February 14, 2018, Meeting Minutes
Plutonium Finishing Plant (PFP) Revised Radiological Stabilization Boundaries
Associated with Ecology/EPA/WDOH to EPA/Ecology letter dated January 9, 2018 re:
PFP Stop Work
Building 2430/Room 223 3:30-4:30pm

The purpose of this meeting was to present to EPA, Ecology, and Washington Department of Health the revised draft PFP Stabilization Radiological Boundaries (referred to PFP Access Control Boundary on the maps); and discuss RL's list of stabilization/risk reduction activities to be completed prior to implementation of the revised boundaries. Drafts of the maps were emailed in advance of the meeting. Tom Teynor cautioned that the revised boundaries are interim boundaries to stabilize the area and may not be the same boundaries that will be used to resume demolition. The revised demolition boundaries will be based on, for example, a revision to the PNNL air dispersion model, and corrective actions resulting from the root cause evaluation and subsequent review team input. An email with RL's list of 19 stabilization/risk reduction activities was distributed.

Plutonium Finishing Plant Boundary Discussion

PFP ACCESS CONTROL BOUNDARY CURRENT STATUS

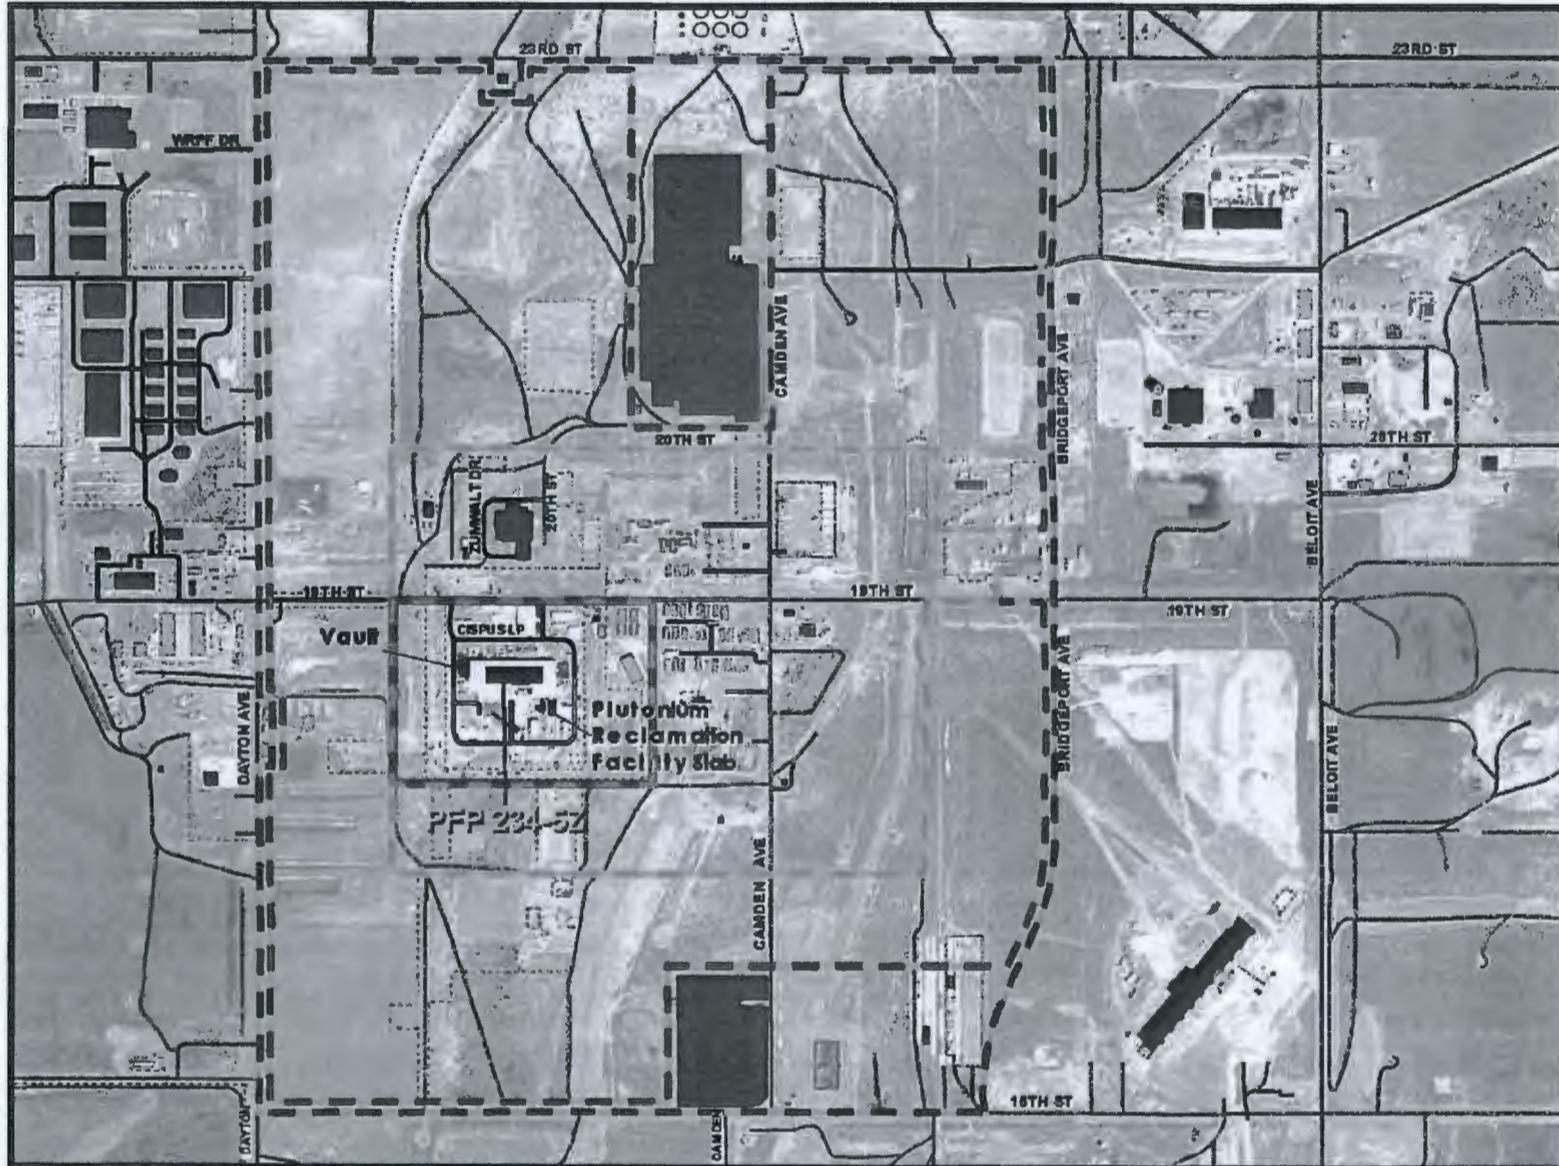
The current PFP Access Control map (Version 1) was shown for comparison and Mr. Wooley pointed out that (1) access to U Plant doesn't need to be controlled as originally implemented, (2) access to T Farm radiological areas will be controlled by WRPS, and (3) a large CA has been established but will allow MSA access to the sewer line. Clarification was provided that a CA does not mean contamination has been found in the boundary area, but where contamination might be; and that personal protective equipment is required.
